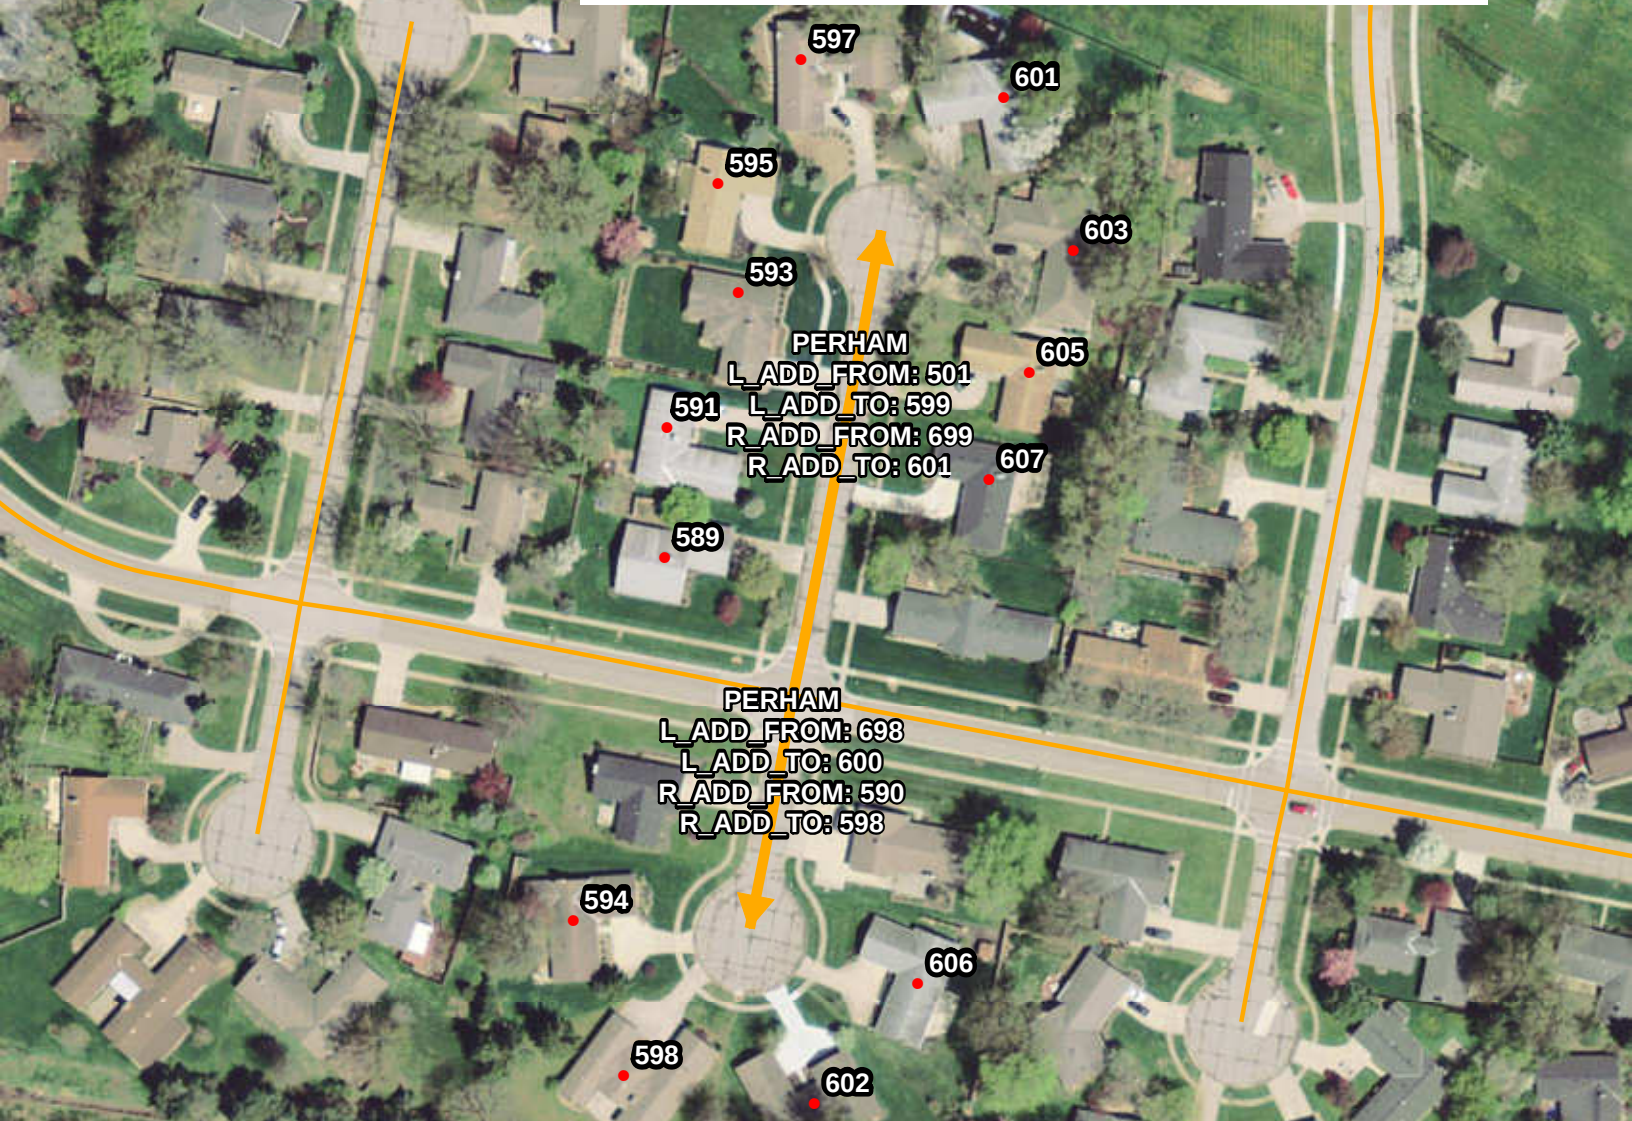
Eastland R ADD FROM and To should be NULL

R_ADD_FROM and TO are reversed
Should be FROM 699 & TO 651

R_ADD_FROM and TO are reversed and out of range
Should be FROM 607 & TO 601

L_ADD_FROM & TO range is not correct
Should be FROM 589 & TO 597

R_ADD_FROM and TO are OK

L_ADD_FROM & TO range is reversed and range could be more accurate
Should be FROM 606 (or maybe 610) & TO 602

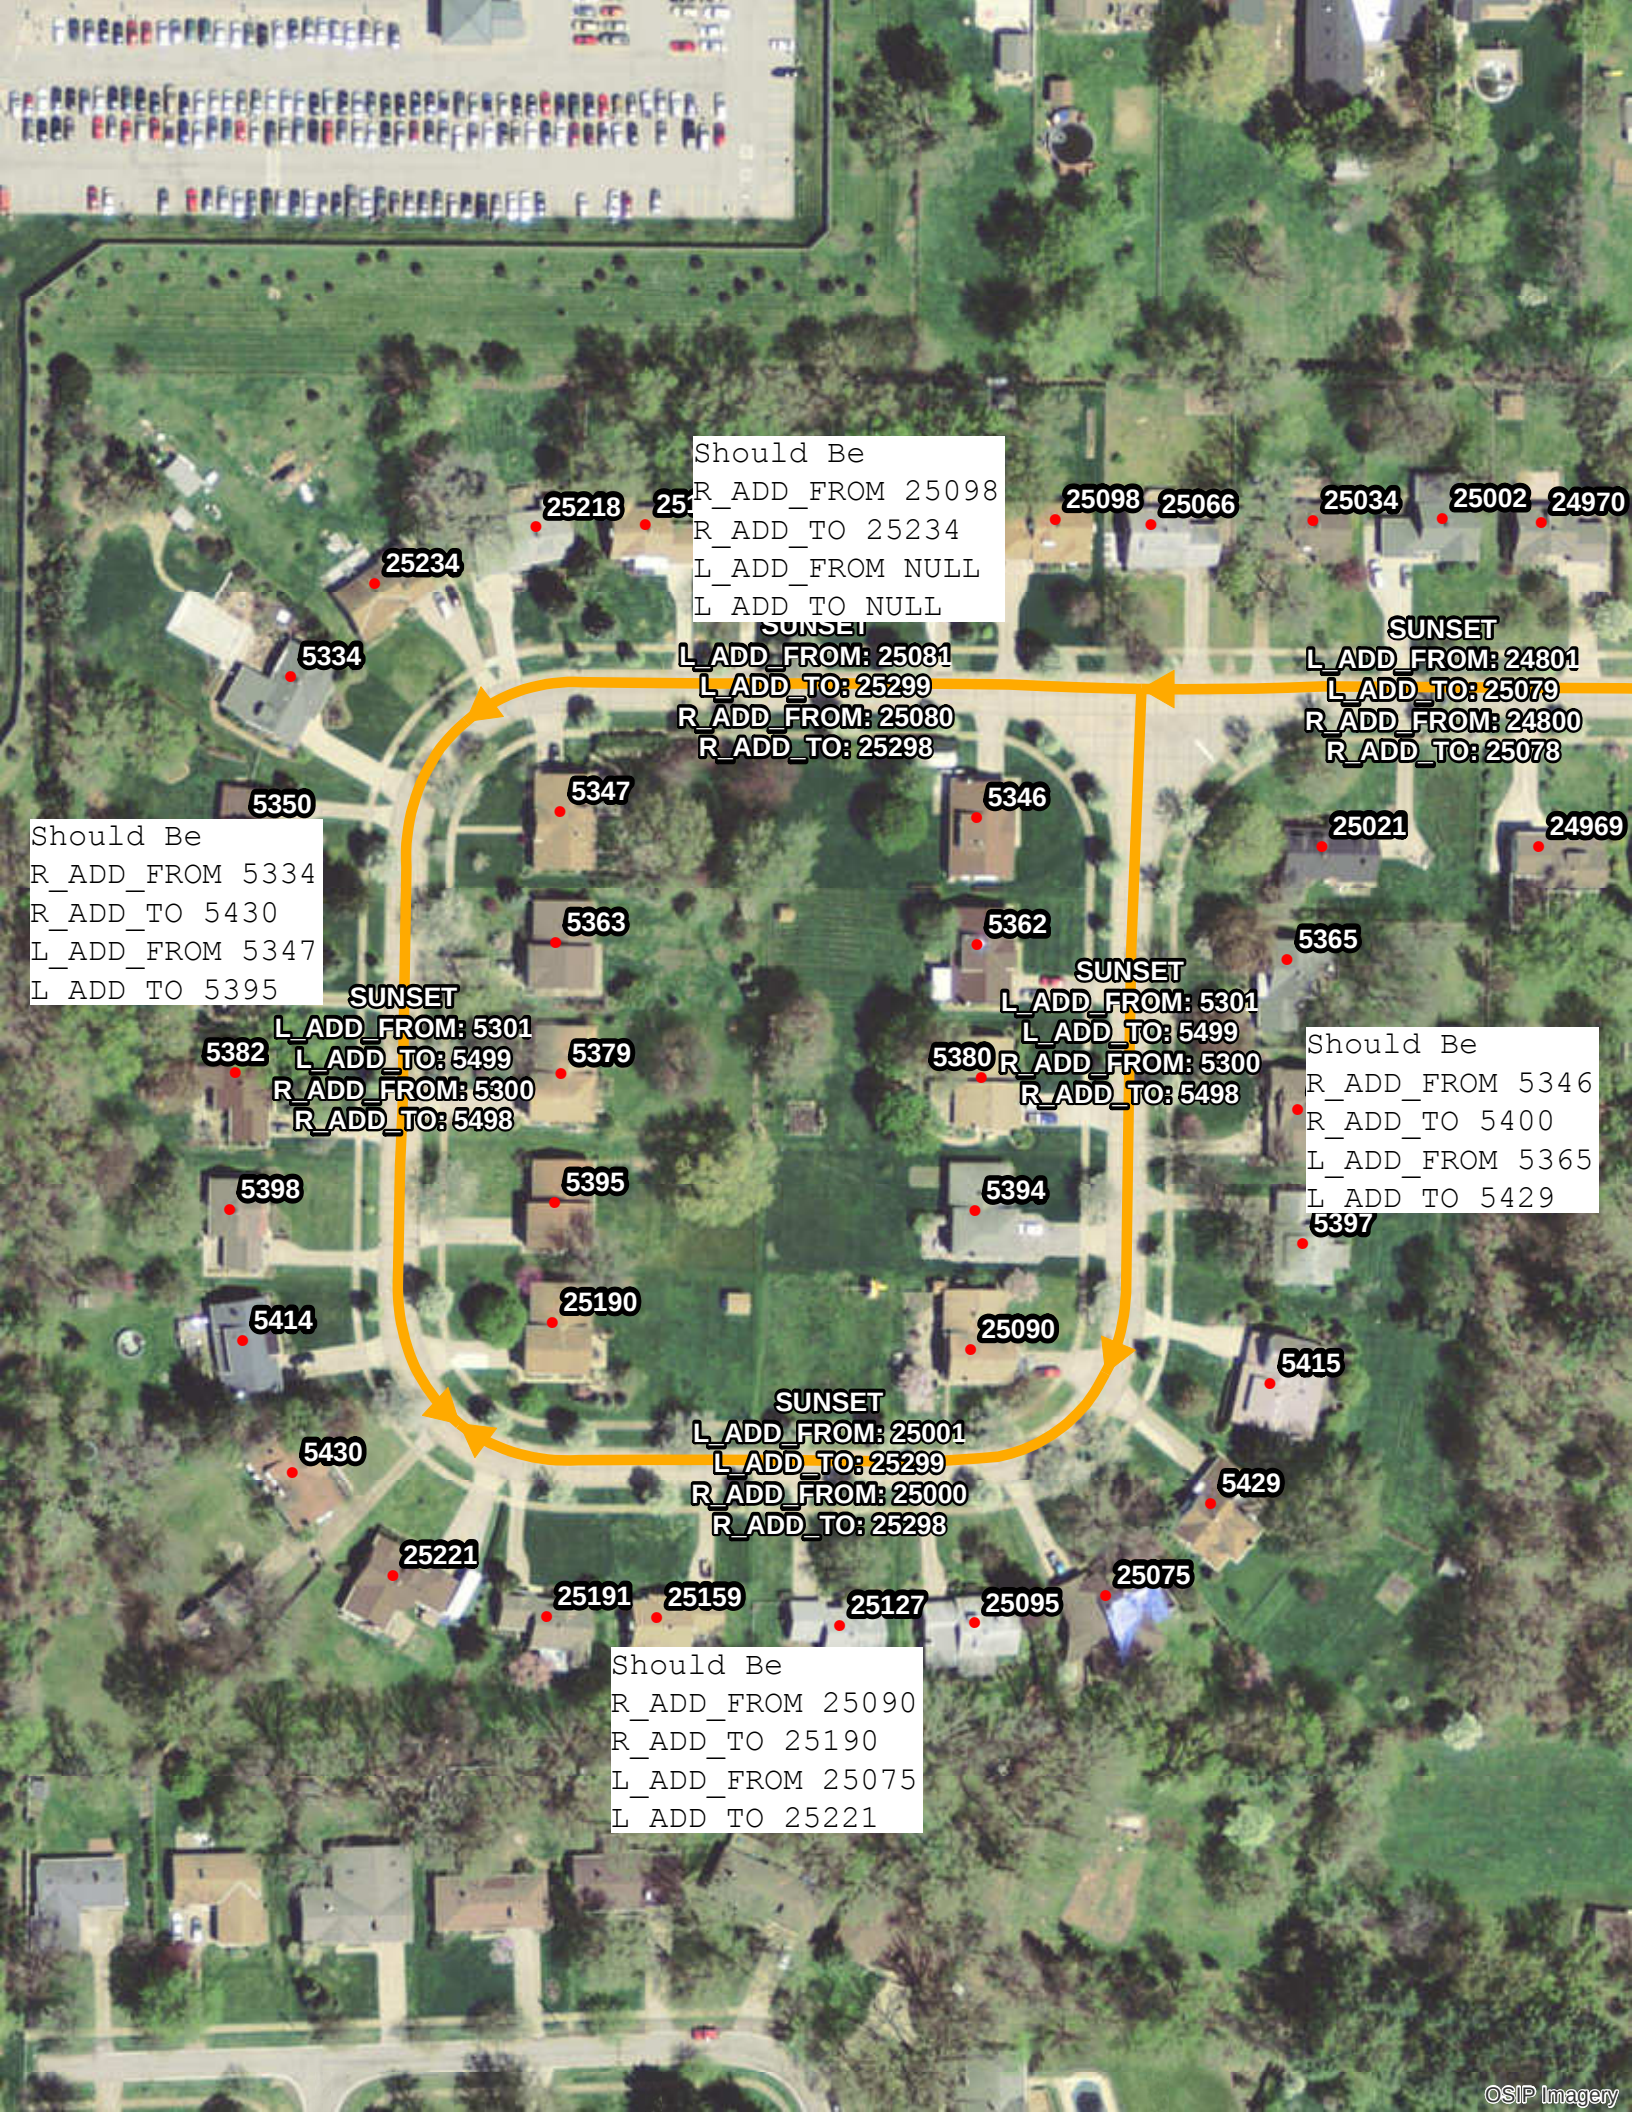
Should Be

R_ADD FROM 25098

R ADD TO 25234

```
L ADD FROM NULL
```

L ADD TO NULL

Should Be

R ADD FROM 5334

R ADD TO 5430

```
L ADD FROM 5347
```

L ADD TO 5395

Should Be

R ADD FROM 5346

R ADD TO 5400

L ADD FROM 5365

L. ADD TO 5429

Should Be

R ADD FROM 25090

R ADD TO 25190

L ADD FROM 25075

L ADD TO 25221
